REVISED (JANUARY 2004)

**TOTAL MAXIMUM DAILY LOAD FOR TURBIDITY, STREAM  
BOTTOM DEPOSITS, AND TOTAL PHOSPHORUS  
In the Canadian River Basin (Cimarron)**

## Appendix G: Response to Comments

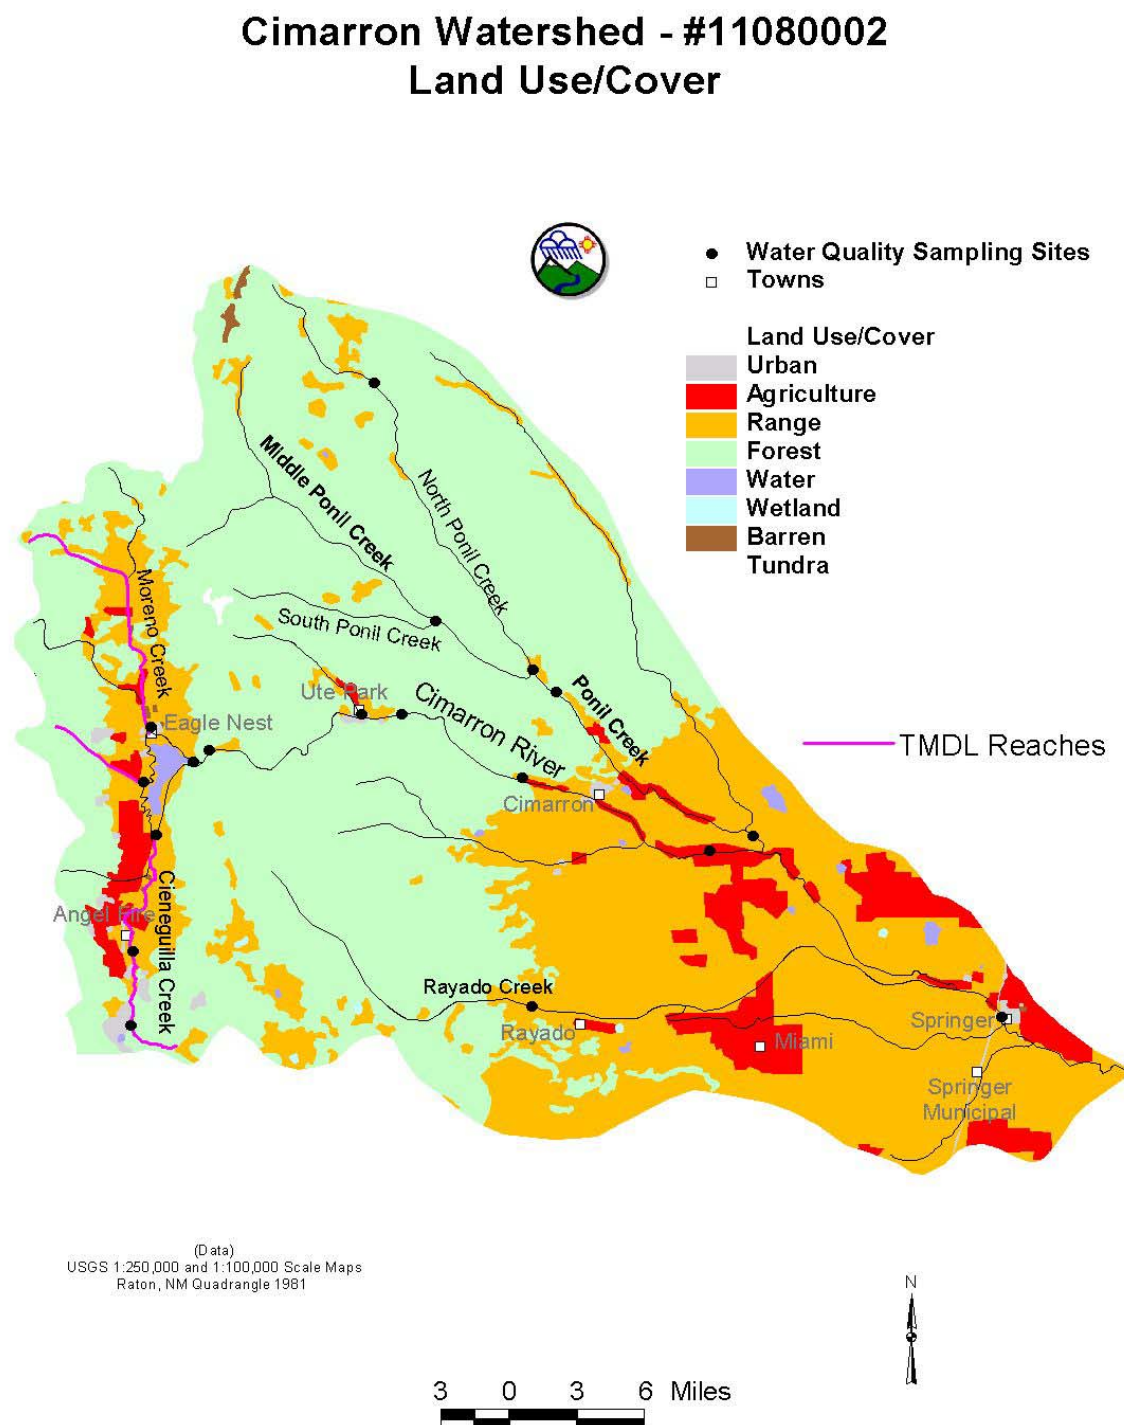
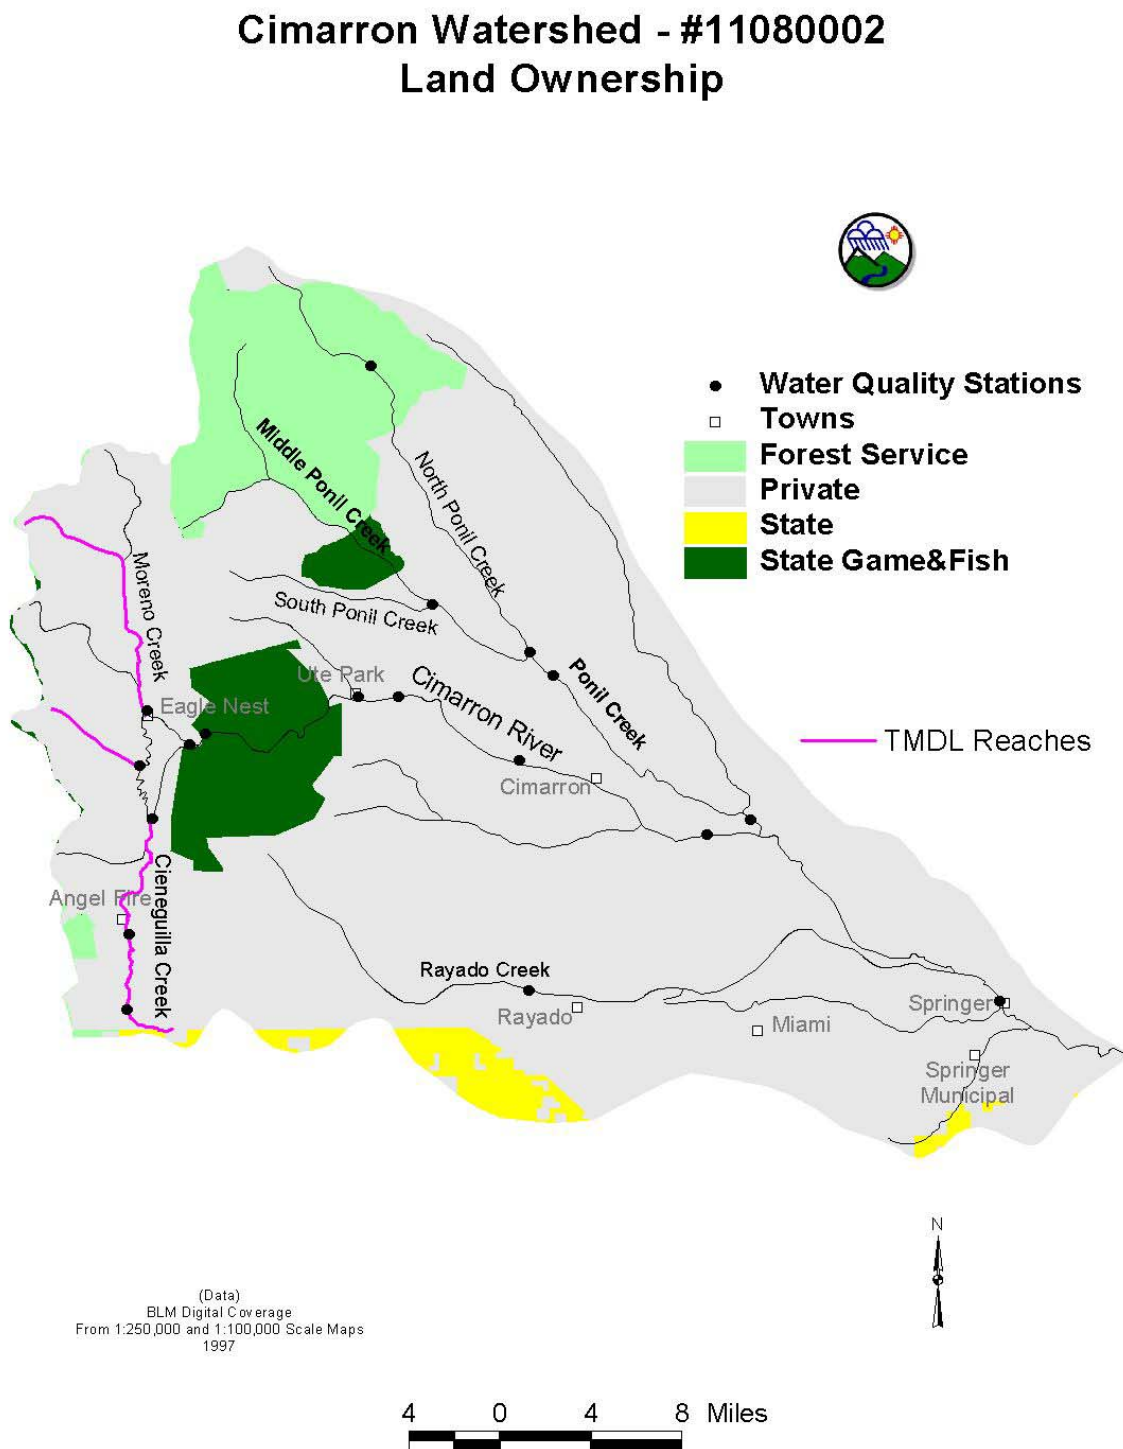
**C** Land use/cover and Cimarron (sic) watershed Figures (1 and 2) - these two figures display various types of information without citation as to the source of the information (ie - land cover and use Southern Rockies - Eco #210, etc.). Also, Figure 1 displays "TMDL segments" with a bold line type indicating various stream segments of interest but Figure 2 does not display the same stream segments with this bold line type in all cases. This is confusing from the standpoint of what these two figures are intended to display or not display.

**R** The two figures have been updated to address your concern. Both figures now show the Impaired Reaches (in pink) that are being addressed in this document.
